SEWAGE DISPOSAL SYSTEM

P 40816
A REPAIR

MARYLAND STATE DEPARTMENT OF HEALTH

SUBDIVISION _____ ROAD 9317 Vollmerhausen Rd LOT _____

P 40816

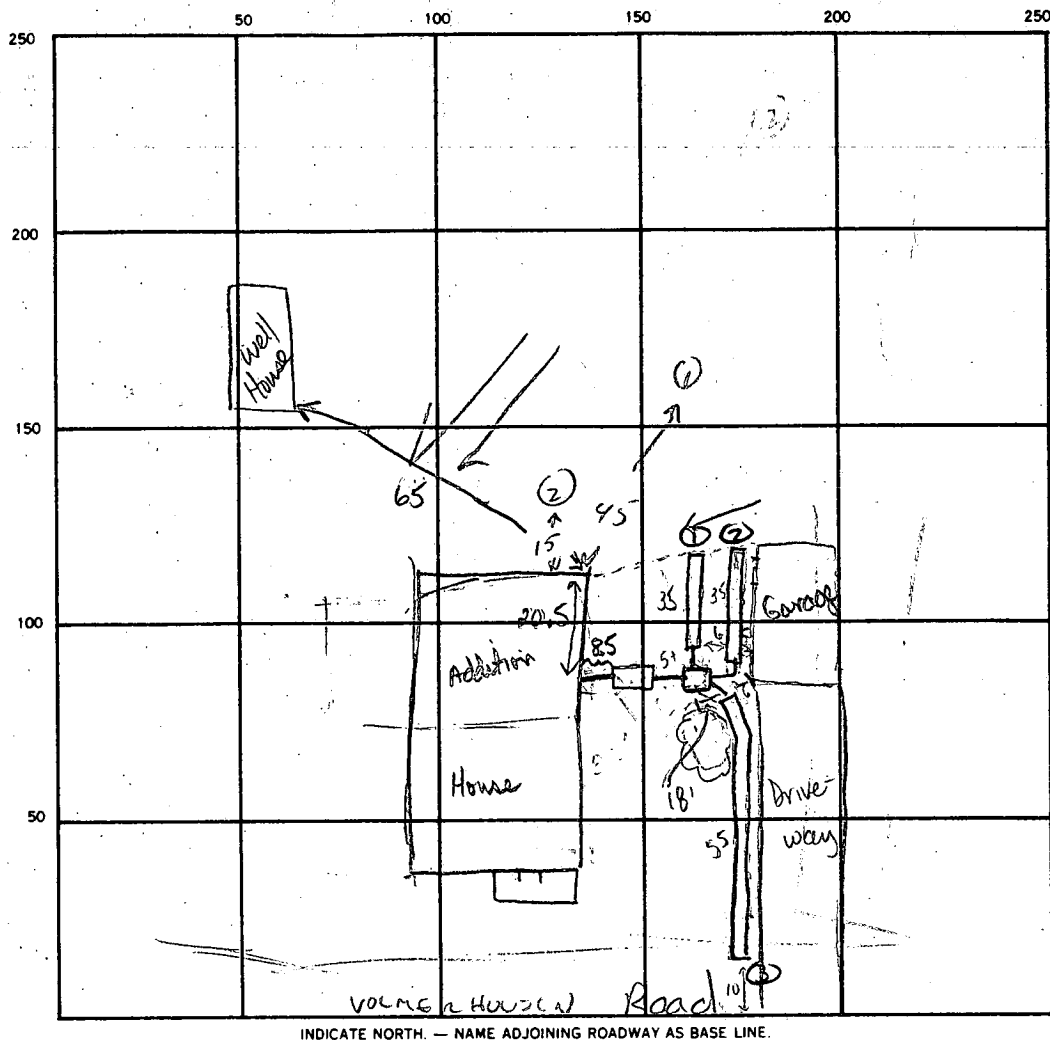
REMARKS 1/18/88- House being Remodeled near public Sewer
No one home left note R/H 1/19/88 JH SAID APPOINTMENT CAN
CANCELLED AFTER I LEFT OFFICE R/H. 7/1/88 outlet from house at 18 inches below grade.
Inlet into s. tank at about 20 inches. Keep inlet into trenches at 2 to 2.5 feet if possible.
Bottom max 3.5 ft. water around tank wall at 4.0 ft. 125 ft trench x 3 ft = 375 sq ft area.

TRENCHES NEARLY COMPLETE. OK TO FINISH & COVER. MUST SEE HOUSE CONNECTION FOR FINAL, C.W.
